SPRING PARK

Regarding: Relocation of Pedestrian Access

**RE: Approval for Relocation of Pedestrian Access Easement: Lot 7 of Spring Park
Subdivision, Evansville, Indiana**

Regarding: Vacation of Drainage Easements in Spring Park Section C
Subdivision

EXHIBIT "A"

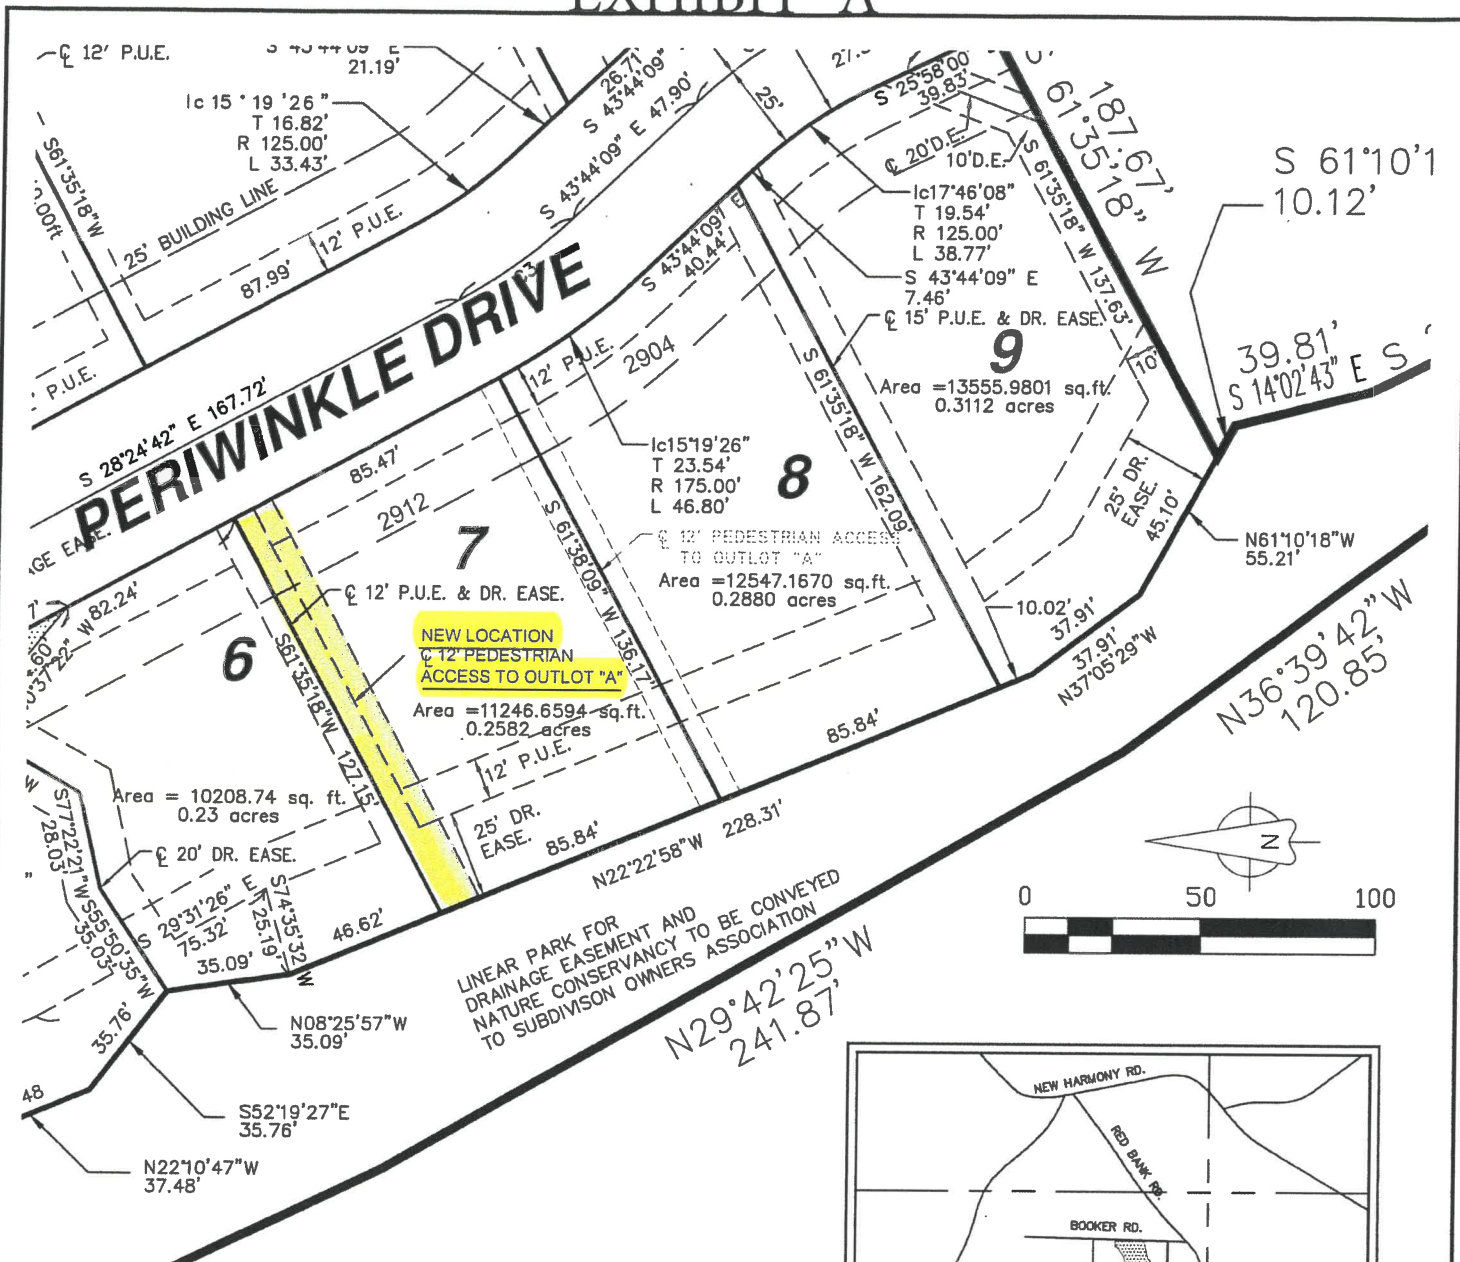
This office is in receipt of your letter dated December 31, 2018 regarding approval of consent to move the Pedestrian Access over an existing Public Utility and Drainage Easement. While this office recognizes that it would be possible for both easements to exist, the following information will be required in order to move forward with your request.

- Provide an engineered drawn cross section showing the entire current easement (on lots 6 and 7), the proposed easement and the centerline of any existing/proposed drainage swale and improvements (trail, paved walk, etc.) proposed within the Pedestrian Easement. If no improvements are planned (especially within that part of the Pedestrian Access that lies over the drainage easement) than state so on the drawing.
- A cover letter to the Vanderburgh Drainage Board seeking a request to a revision to the Approved Drainage Plan, with the approval date of the original final drainage plan, seeking the modification.

This office is in receipt of your letters dated December 31, 2018 and January 25, 2019 regarding approval of consent to move the Pedestrian Access over an existing Public Utility and Drainage Easement. With the clarification that no alteration will be done to the existing drainage easement this office has no objection to the movement of the pedestrian easement to the proposed location.

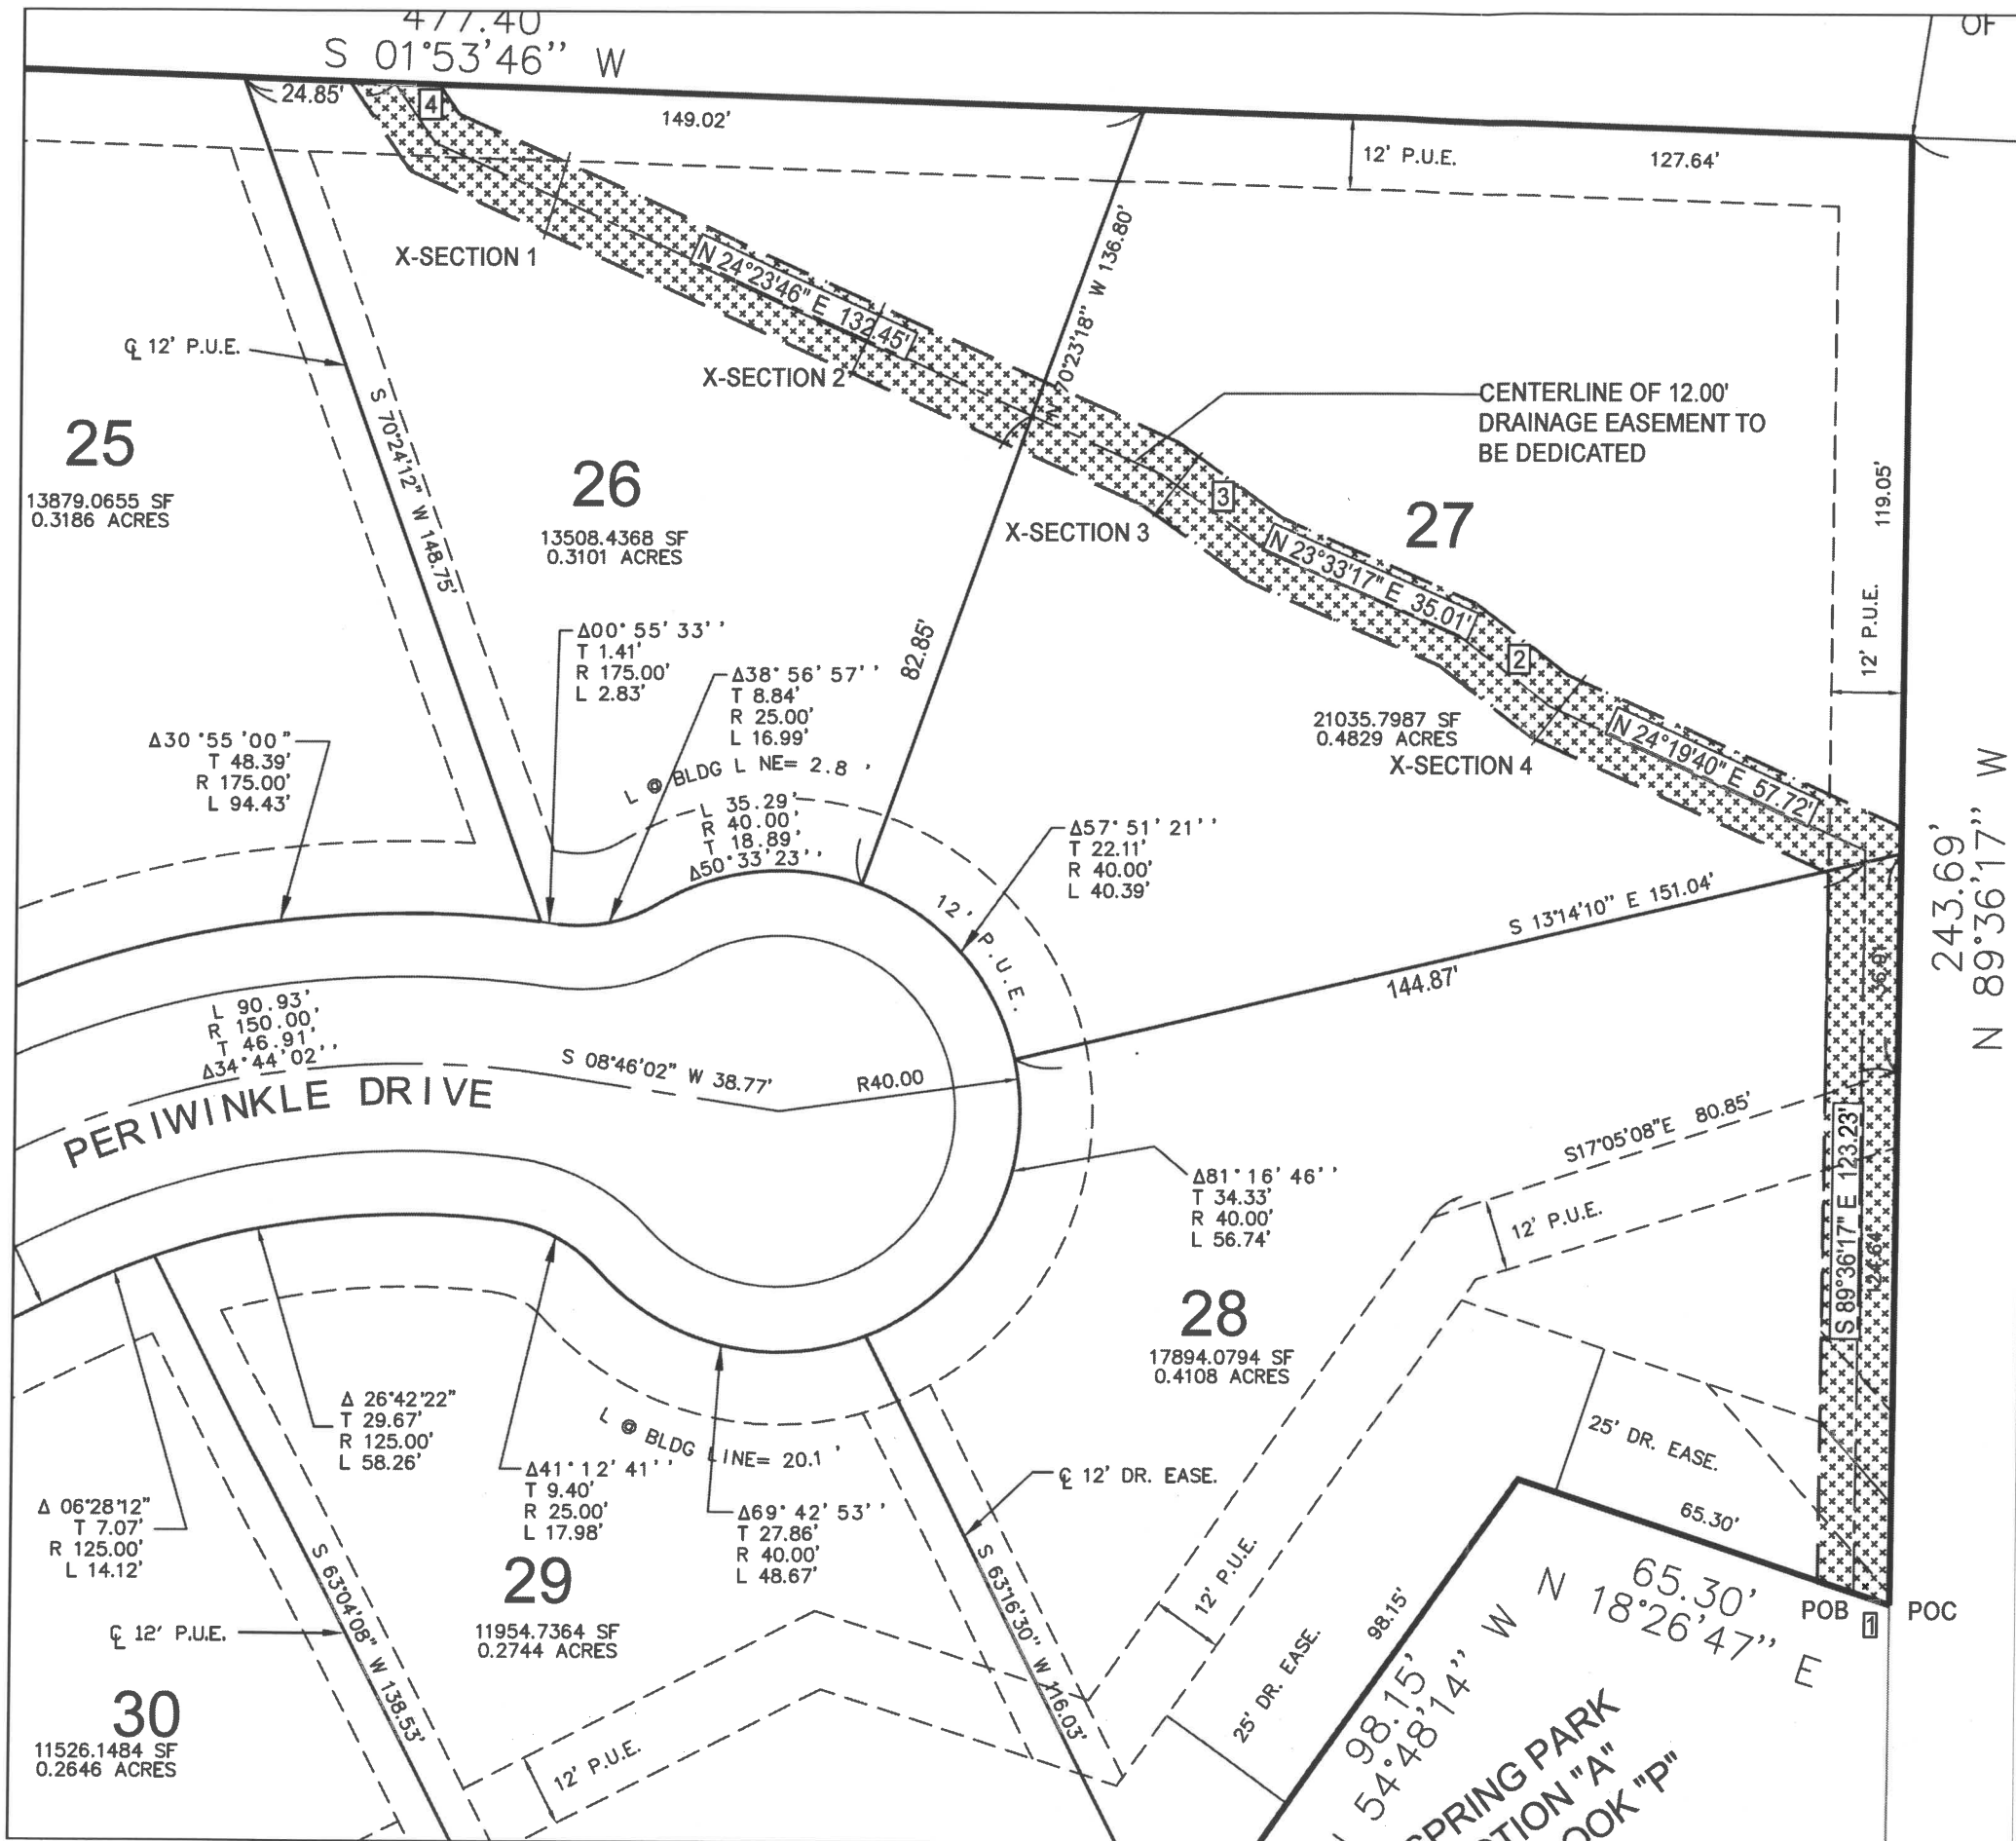
Lots 26, 27, and 28 of Spring Park Sec "C", (2821, 2815, and 2814 Periwinkle Drive respectively) had a drainage easement dedicated at a larger than needed 20' wide easement for an overland ditch.

Over the years as Spring Park has been developed, cleared, and future lots prepared for sale, the developer has removed much of the overgrowth and brush from the lots. To date, the existing ditch is much smaller and was able to be located accurately in the field.

D&R Development, subdivision developer and owner, would like to vacate the existing drainage easement and dedicate a new drainage easement over the ditch at it's real world position. This allows Lots 26 and 27 to have more accessible building sites from the roadway versus the proposed building sites as per the current plat and easement location.

- The Vanderburgh County Surveyor does not have any proposed drainage facilities in the Drainage Easements that are proposed to be vacated.
- The Vanderburgh County Surveyor agrees to release its rights in the area that is proposed to be vacated.
